# 1986 - 1987 Corvette: Service Bulletin: Clutch Master Cylinder Push Rod Bushing

**Subject:** Clutch Master Cylinder Push Rod Bushing  
**Model Year:** 1986 - 1987 Corvette with Manual Transmission  
**Source:** Chevrolet Dealer Service Bulletin  
**Bulletin No:** 87-114, Section 7C  
**Date:** April, 1987

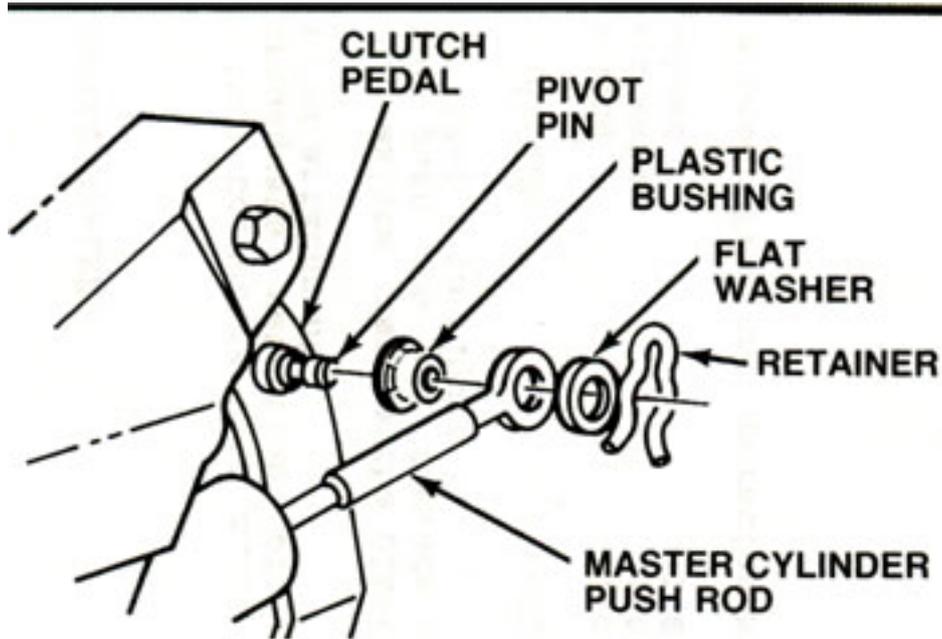
Some 1986 or 1987 Corvettes with manual transmissions may experience inadequate retention of the clutch master cylinder push rod attachment.

If the condition exists, remove the plastic bushing from the master cylinder push rod and replace with the following service parts. (Refer to Figure 1):

<b>DESCRIPTION</b>	<b>PART NUMBER</b>
Bushing	14080233
Flat Washer	120395
Retainer	148149
